Subject: **ADJ2018-0009 / DR2018-0177 / LD2018-0042 / TP2018-0012**
2nd and Lombard Apartments

STAFF REPORT

PROPOSAL: **2nd and Lombard Apartments**
ADJ2018-0009 / DR2018-0177 / LD2018-0042 / TP2018-0012

**FACILITIES REVIEW COMMITTEE
TECHNICAL REVIEW AND RECOMMENDATIONS
ADJ2018-0009 / DR2018-0177 / LD2018-0042 / TP2018-0012
2ND AND LOMBARD APARTMENTS**

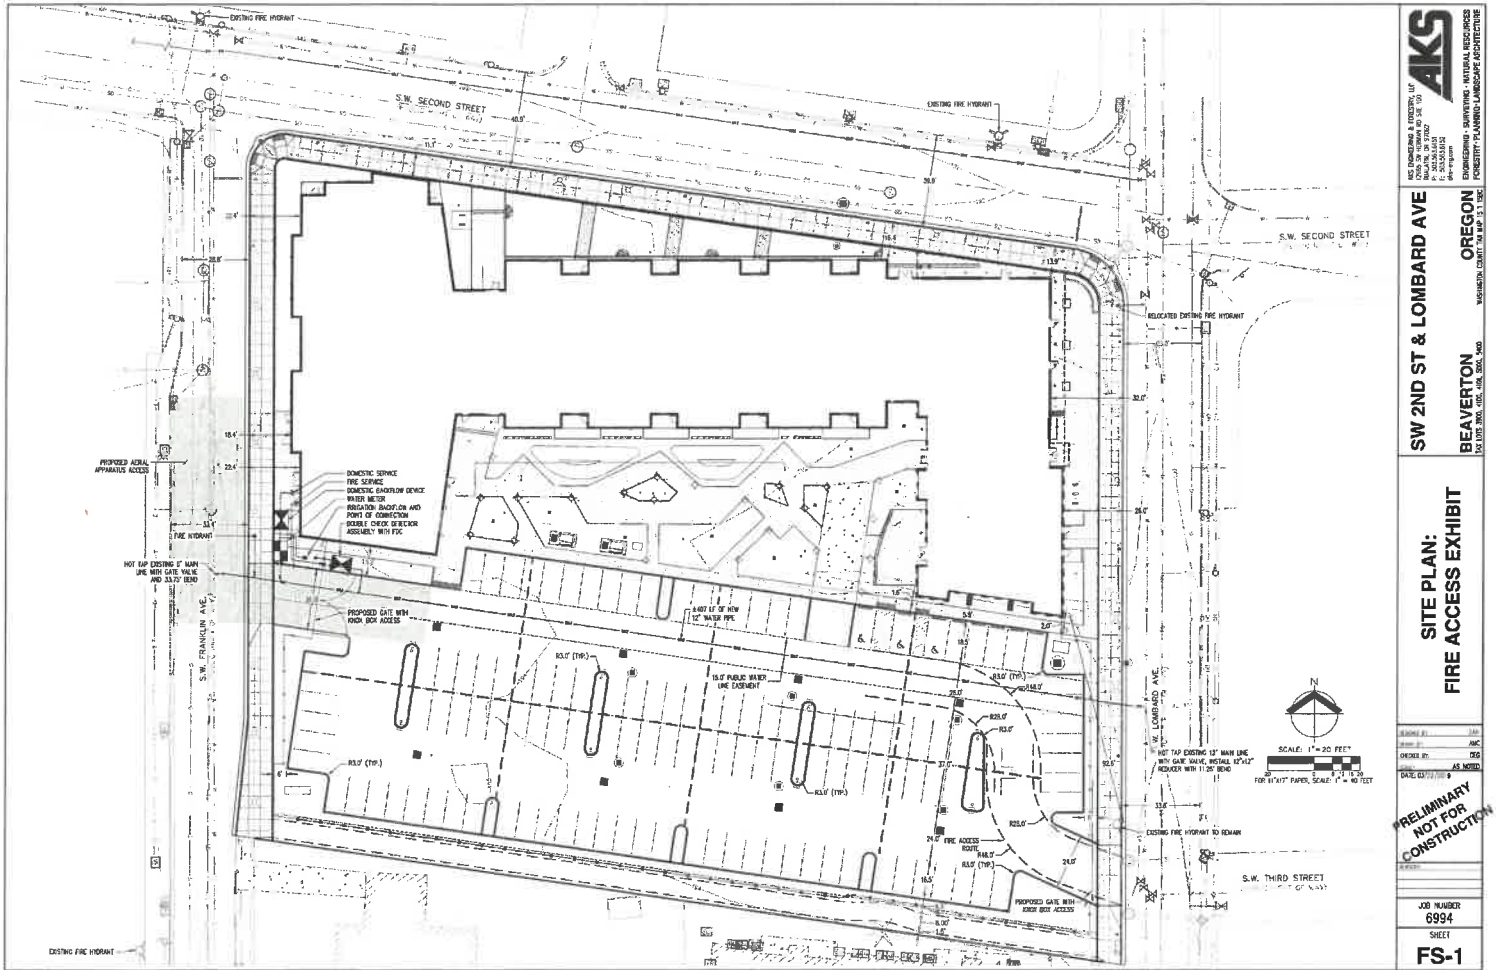
Due to the size of this structure an Emergency responder Radio Coverage (ERRC) system will be required.

The customer has opted to go with the fee-in-lieu or MERC system. Reminder that the forms must be filled out and approved prior to issuance of building permits.
